**ADDENDUM # 2**

**RFP# 7599852**

**TITLE: Lease of Commercial Office Space Department of health Office  
State Medical examiner**

# OSME CONCEPTUAL FLOOR PLAN

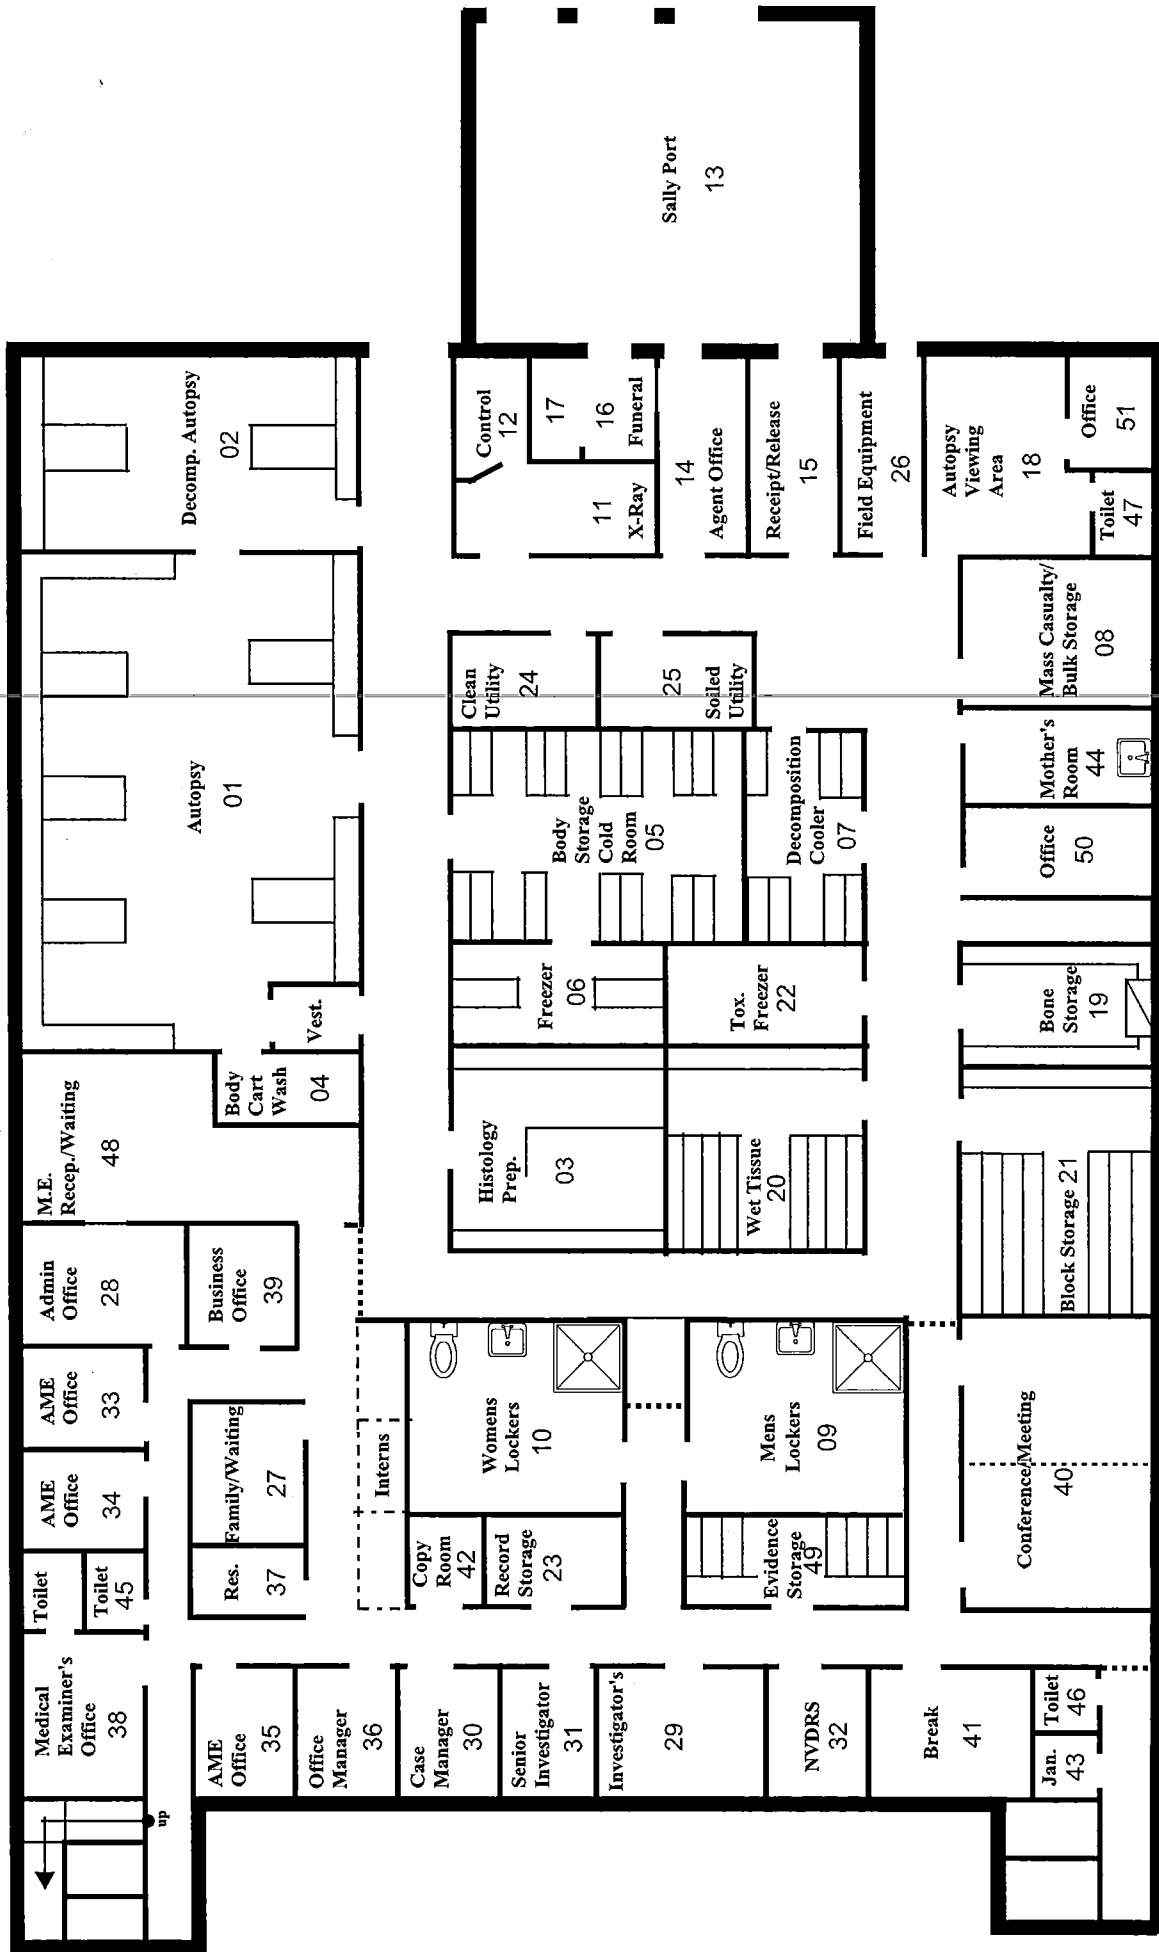
The following spaces are listed in the list of “Conceptual Functional areas”, but not shown on the floor plan:

1. Decomposition Cooler @ 242sf (there is a “Cooler” on the floor plan, but given its’ size, I assume that is the “Body Storage Cold Room” @ 968sf)
2. Mass Casualty Room @ 242sf
3. Drop off/Waiting @ 91sf
4. Slide and Block Storage (Specimen) @ 484sf (this is probably the room to right of Mother’s Room, but need to confirm if so.)
5. Family/Waiting Room @ 121sf
6. Resident Office @ 121sf (there is a space on floor plan labeled “Resid”, but I assume this is part of the area called “Business/Administrative Office @ 545sf on the list)

The following spaces are shown on the floor plan, but missing from the list of rooms:

1. M.E. Reception/Waiting (I assume this is not the “Drop off/Waiting” area @ 91sf listed above, as space on floor plan is clearly much larger than this)

2. EMR (small space lower left on floor plan; need size)
3. 2 Storage Rooms (as noted above, I assume the large storage room to right of the Mother’s Room is intended to be the Slide and Block Storage form the list of rooms, but need to have this confirmed). There is a second storage room on the floor plan to left of Women’s Lockers that does not match anything on the list of rooms. we need a size/square footage for this room)

4. Alcove (small space to left of Field Equipment Room; need to assign a size/square footage)
5. Soiled Utility (need clarification if this space is intended to be part of the “Clean and Dirty Linen Storage” @ 182sf on the list of rooms, or is something separate. If part of Clean and Dirty, is it a total of 182sf, or 2 rooms at 182sf each?)

6. File Storage (room to left of Men's Lockers, not shown on list. What is desired size/square footage?)

**For answers to questions 1-6, please see Updated Conceptual Floor Plan and Updated Functional Square Footage located in Addenda 2.**

**\*Please be advised that this is a Conceptual Floor Plan.**

**For answers to questions 1-6, please see Updated Conceptual Floor Plan and Updated Functional Square Footage located in Addenda 2.**

**\*Please be advised that this is a Conceptual Floor Plan.**
